Tennessee Valley Authority, 1101 Market Street, Chattanooga, Tennessee 37402

CNL-20-004

Subject: **Watts Bar Nuclear Plant, Units 1 and 2, License Amendment Request to Revise Technical Specification 3.3.5, "LOP DG Start Instrumentation," (WBN-TS-20-01)**

Evaluation of the Proposed Change

Figure 1
Excerpt from 6.9 kV Shutdown Power Train A and B Schematic Diagram

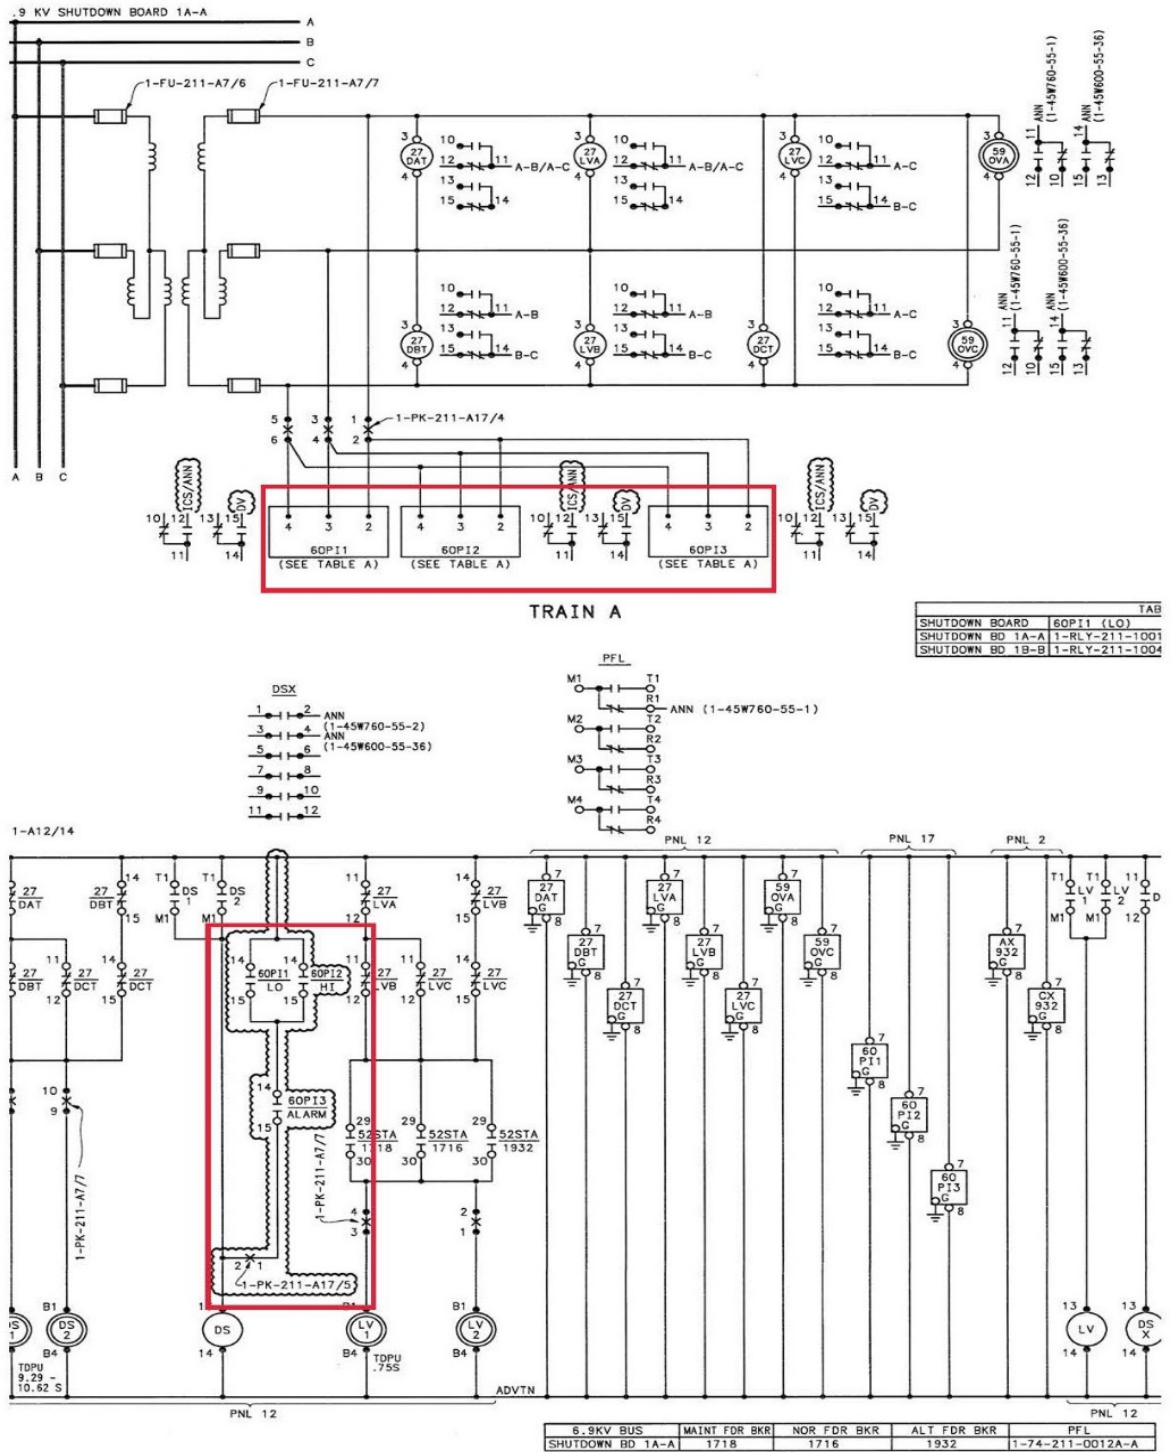
During the performance of maintenance on the 6.9 kV SDBD 1A-A, all three unbalanced voltage relays (i.e., 60PI1, 60PI2, and 60IP3) are removed from service. As shown in Figure 1, the relaying for open phase conditions is monitored by the three unbalanced voltage relays on each SDBD. The maintenance activities associated with the 6.9 kV SDBD 1A-A will require the unbalanced voltage relays to be removed from service for board cleaning/inspection and will also allow restoration of the board. The maintenance for the WBN Unit 1 6.9 kV SDBD 1A-A is scheduled to be performed during the WBN Unit 1 Cycle 16 refueling outage, which is scheduled to commence on

April 23, 2020. During this maintenance, WBN Unit 1 will be defueled and the 6.9 kV SDBD 1A-A will be de-energized. Because the electrical distribution system is shared between WBN Units 1 and 2, de-energizing the unbalanced voltage relays of 6.9 kV SDBD 1A-A also affects WBN Unit 2. Therefore, without this proposed license amendment, WBN Unit 2 would be required to enter TS 3.0.3.
